ZONING DRAINAGE REPORT

Villages at Troon Phase 3

ZONING DRAINAGE REPORT COMMENT RESPONSE

Subject: Villages at Troon Phase 3
Zoning Drainage Report Review
Case number: 27-ZN-2016

VILLAGES AT TROON - PHASE 3
 GRADING AND DRAINAGE PLAN
 SCOTTSDALE, ARIZONA

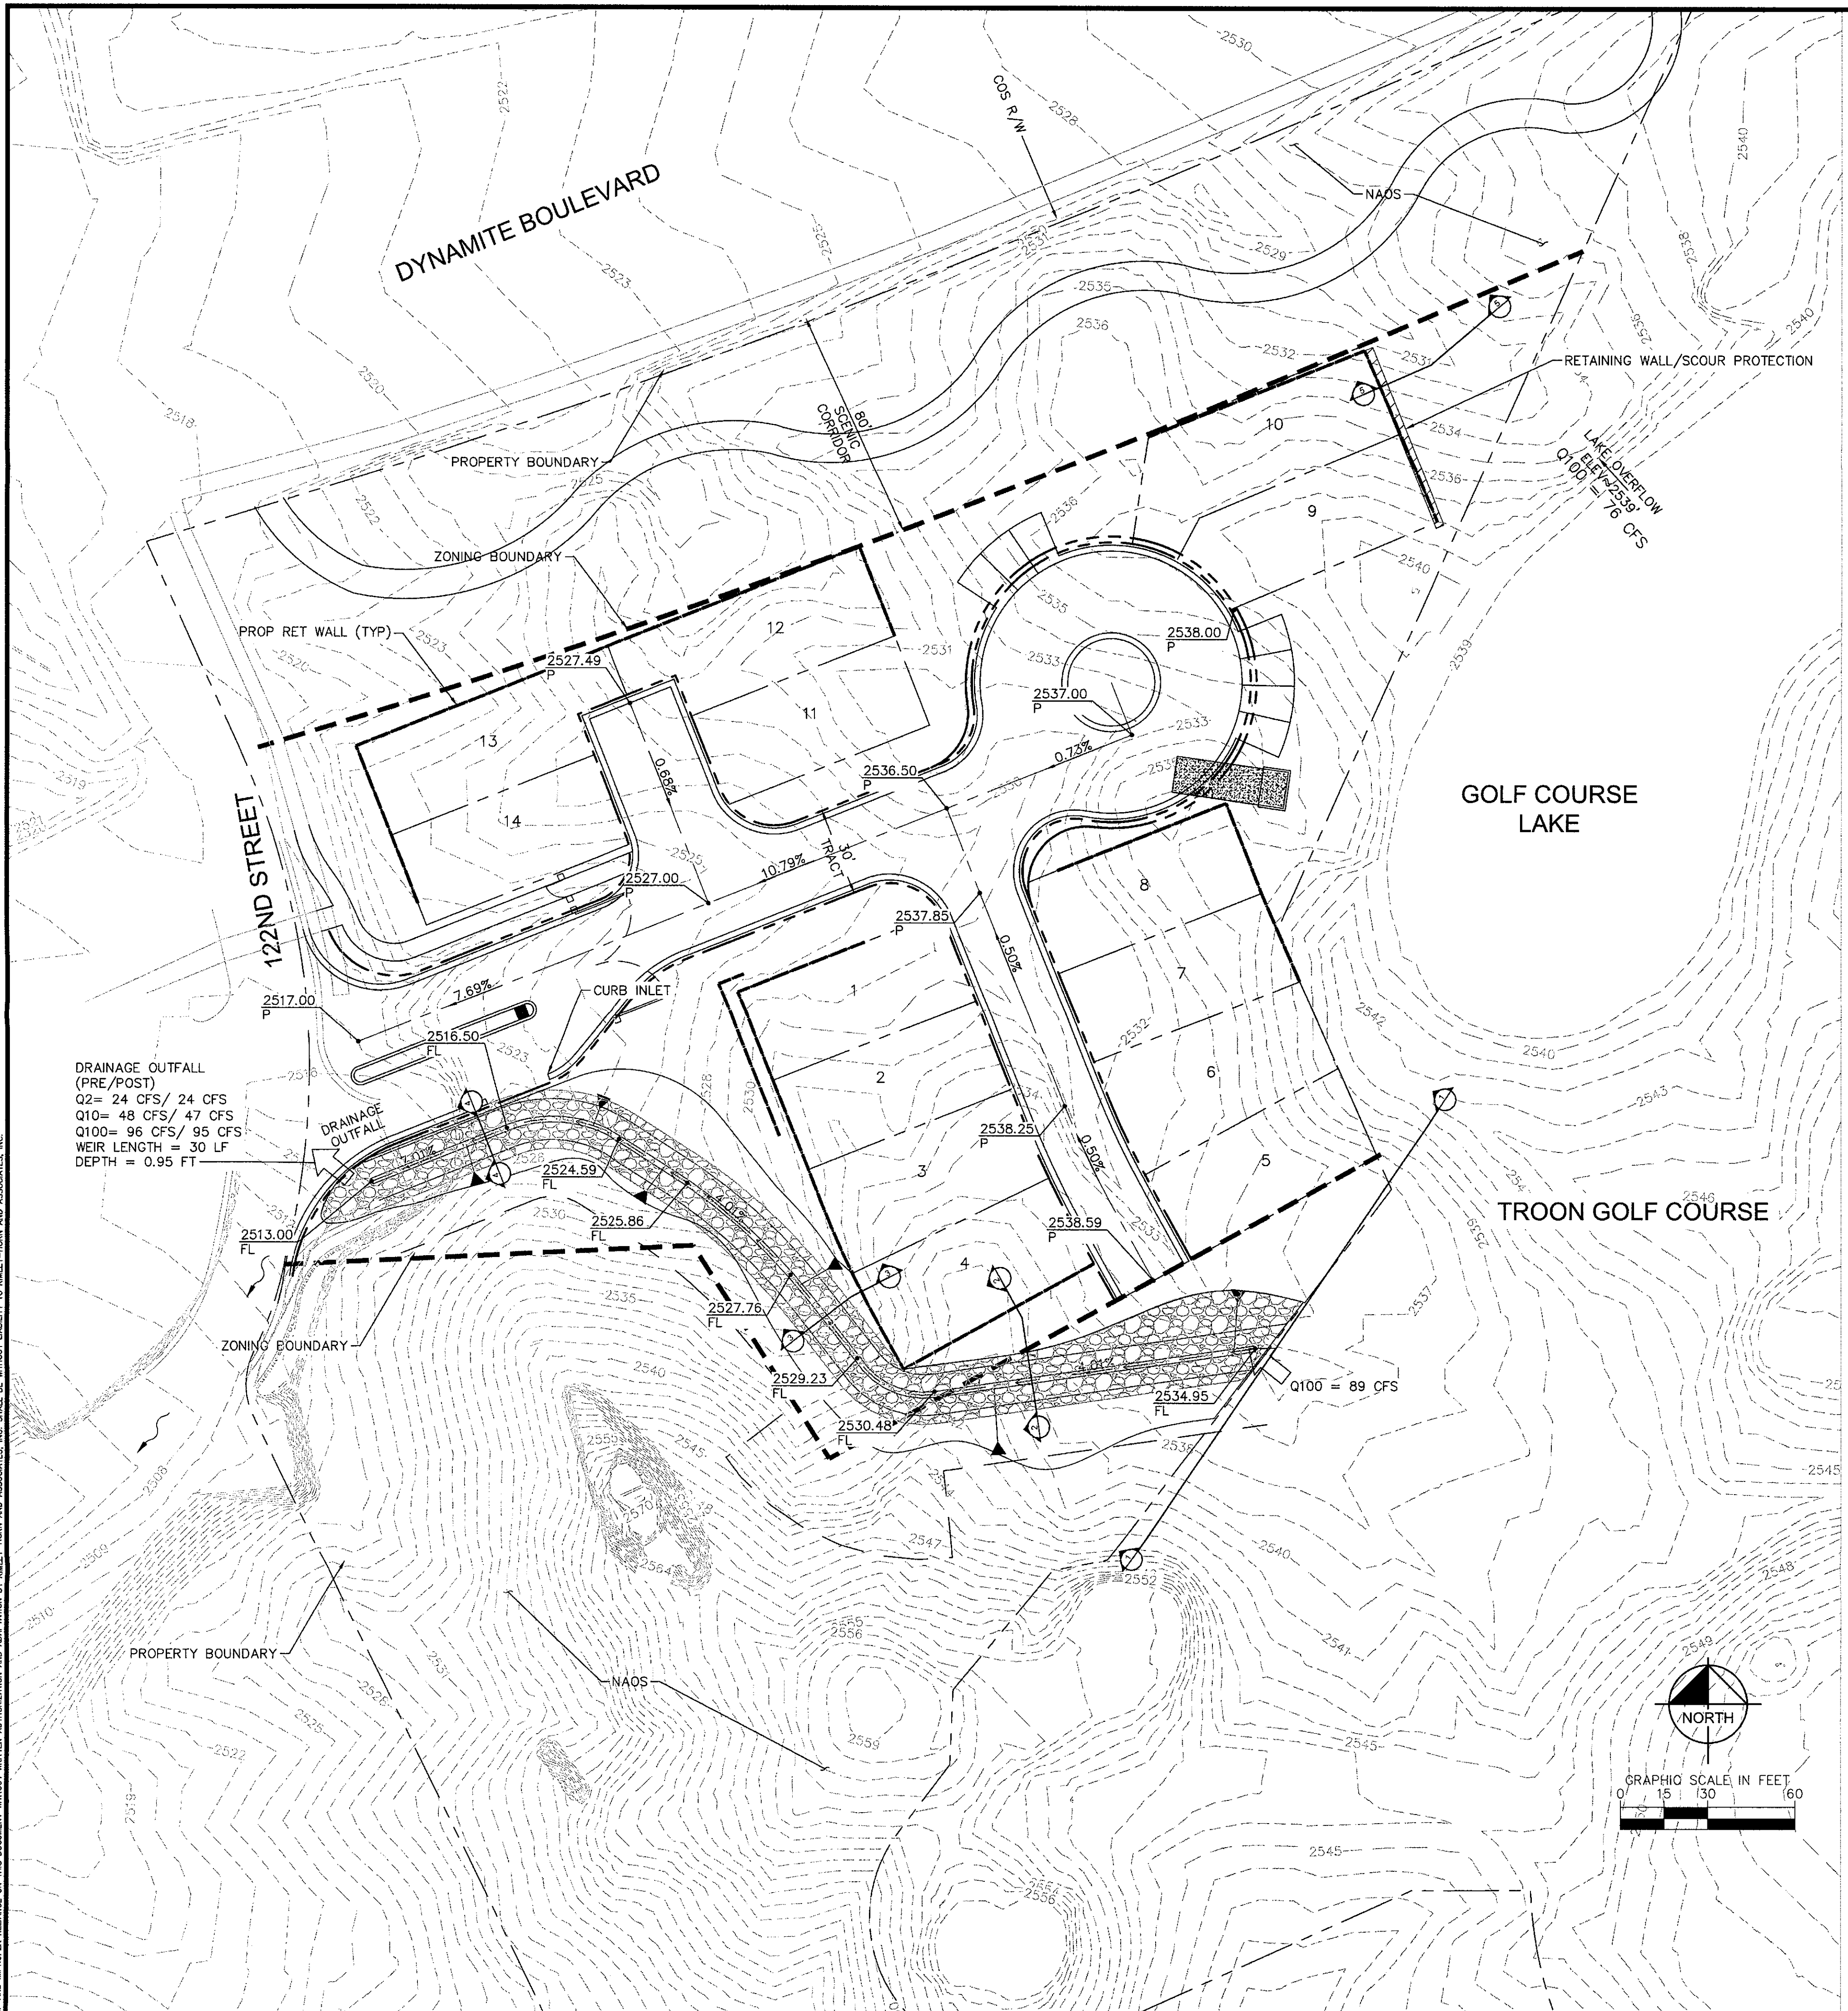
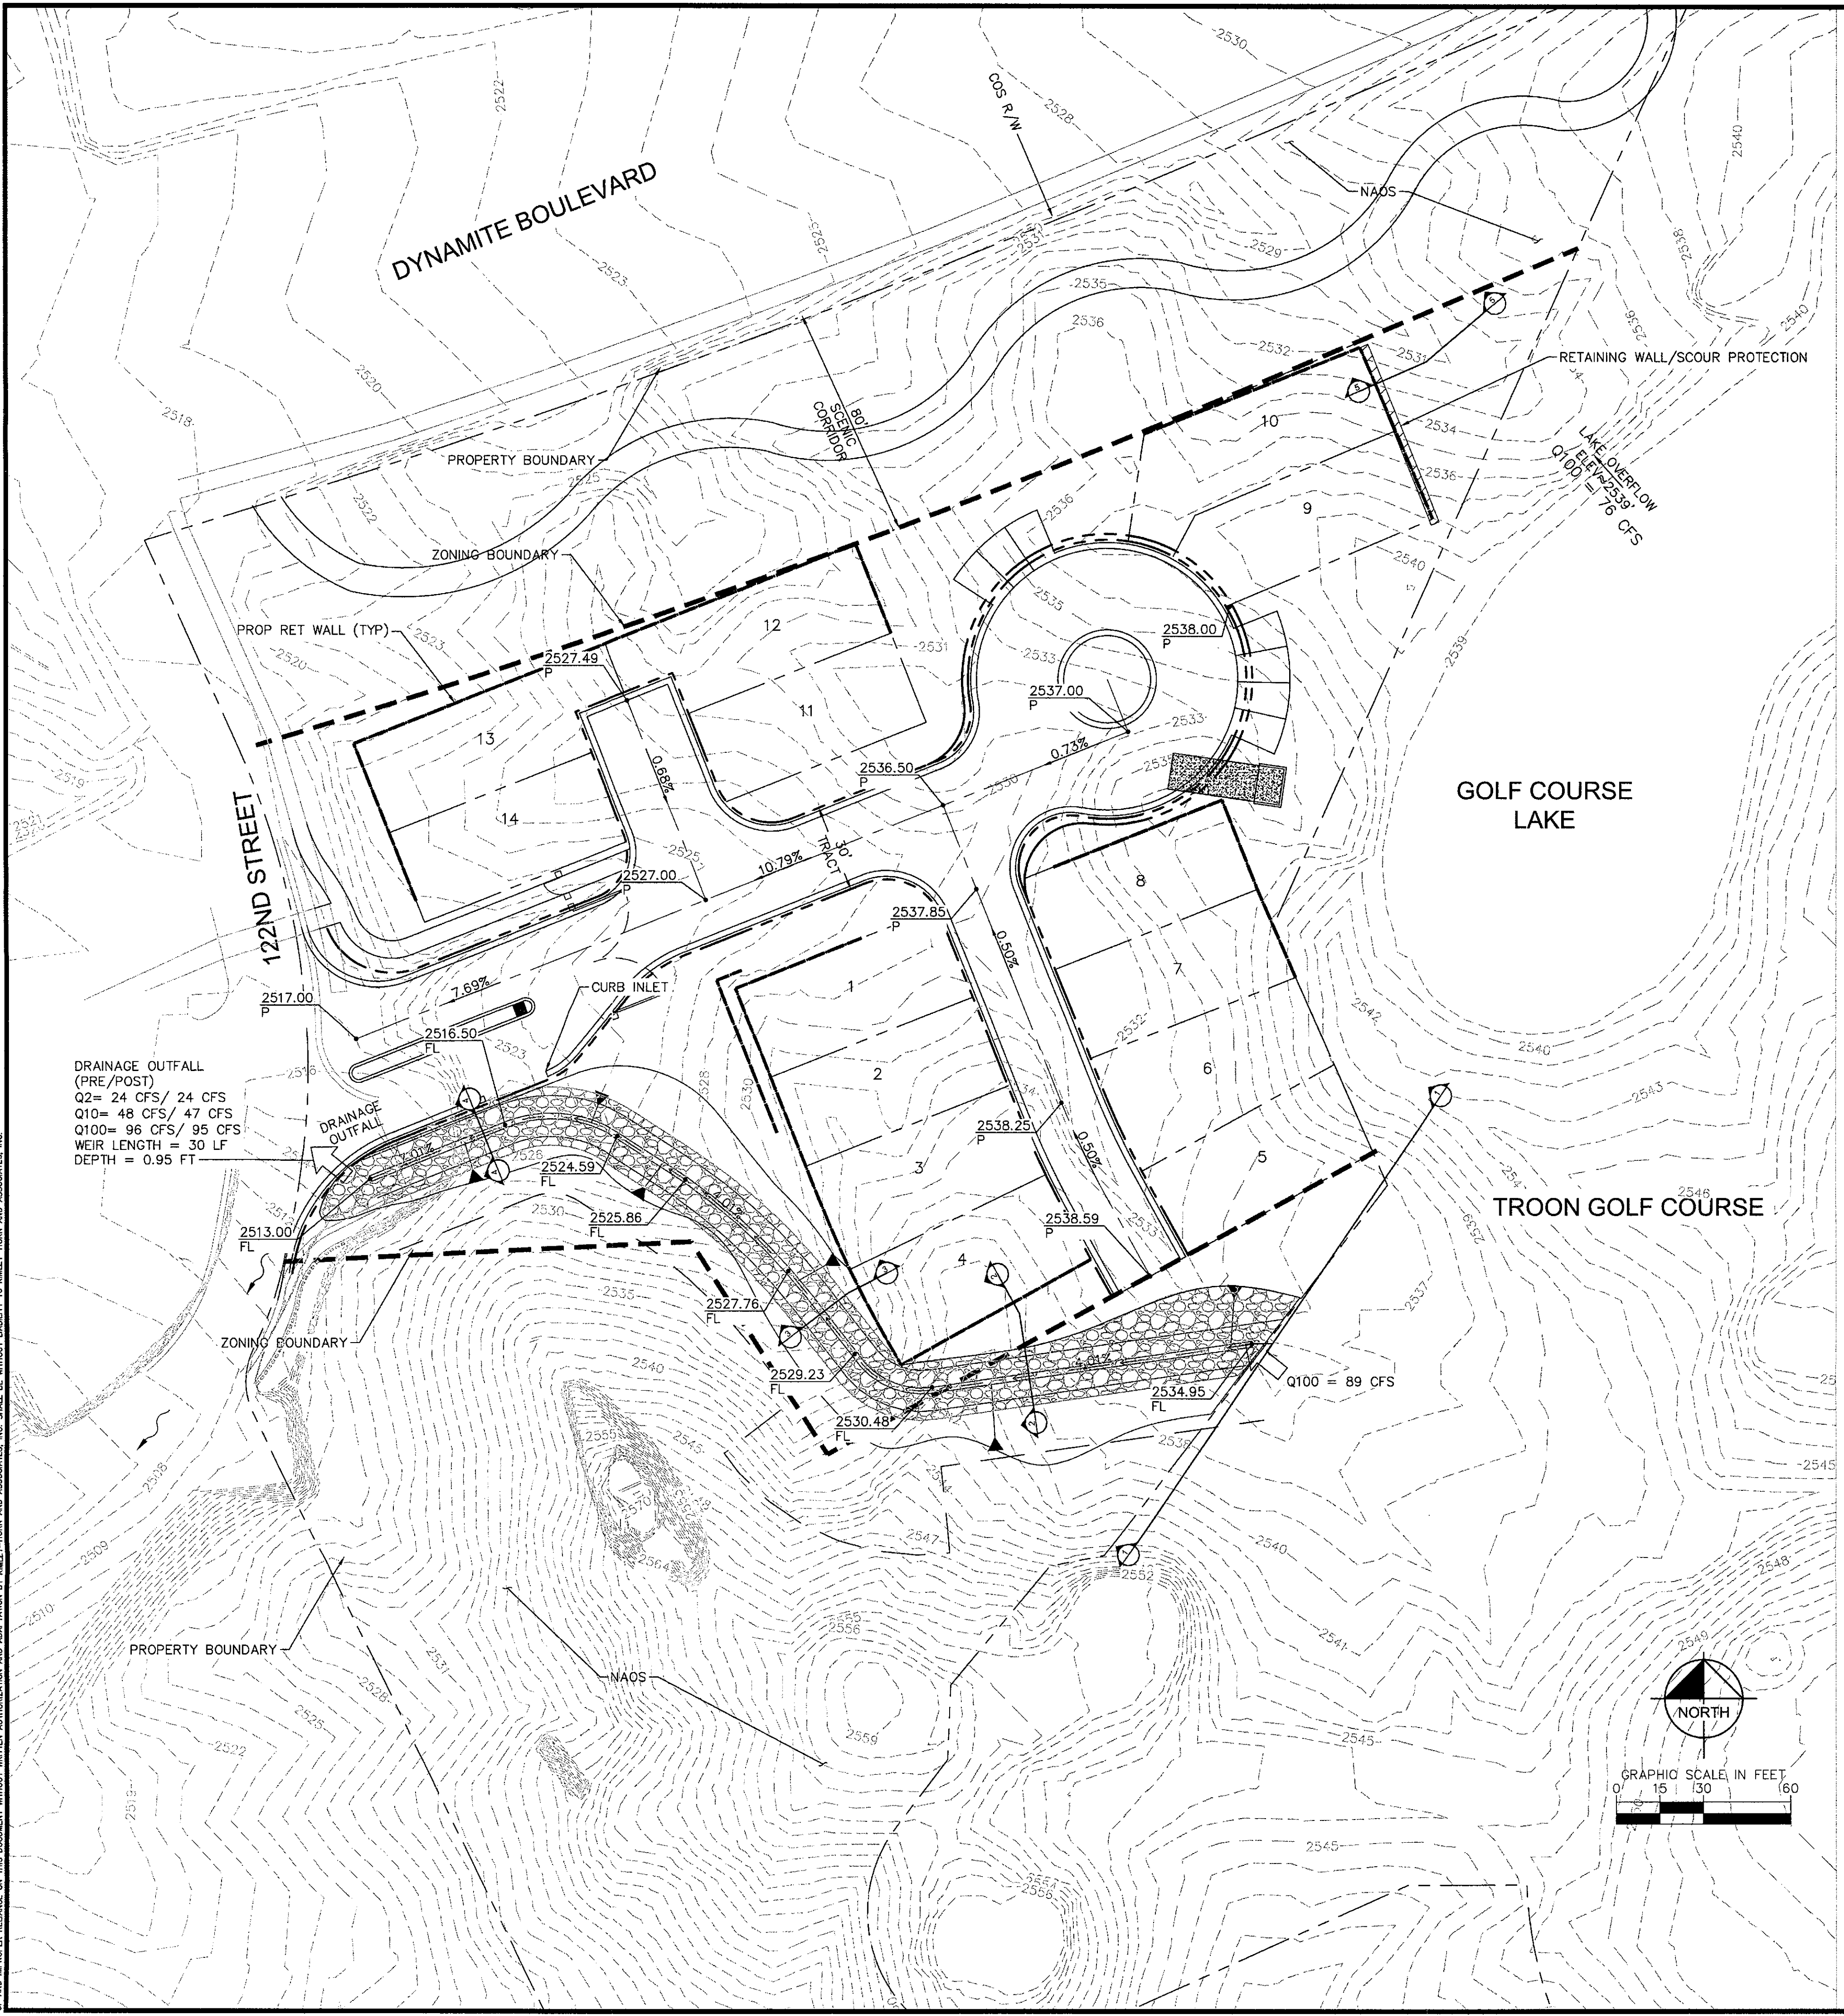
2. The preliminary grading and drainage plan (plan), in conjunction with the report, comprise the two primary pieces of information we review to evaluate the proposed project from a stormwater perspective. As such, the two must provide adequate information to allow this evaluation. Grading and drainage plan was not provided with 1st submittal. Please submit plan with 2nd review.

5. Show details of proposed improvements within the City right of way.

7. For proposed site, privacy, or retaining walls, the top and base of wall elevations should be provided on the plans. Elevations should be provided at ends, changes in elevation, or as needed to provide a reasonable level of definition of the elevations of the walls.

The grading and drainage plan is provided. Level of detail with flow and cross section information has been provided as discussed with the City at meeting held Monday, January 23.

A curb cut for street conveyance has been added to the grading and drainage plan to be located within a private tract. No other drainage improvements are within the City right-of-way.

As discussed with the City at a meeting held Monday, January 23, additional cross section information and conceptual GD plan have been provided for the City's review. It was discussed that additional wall elevations would not be required but location and erosion protection would be identified.
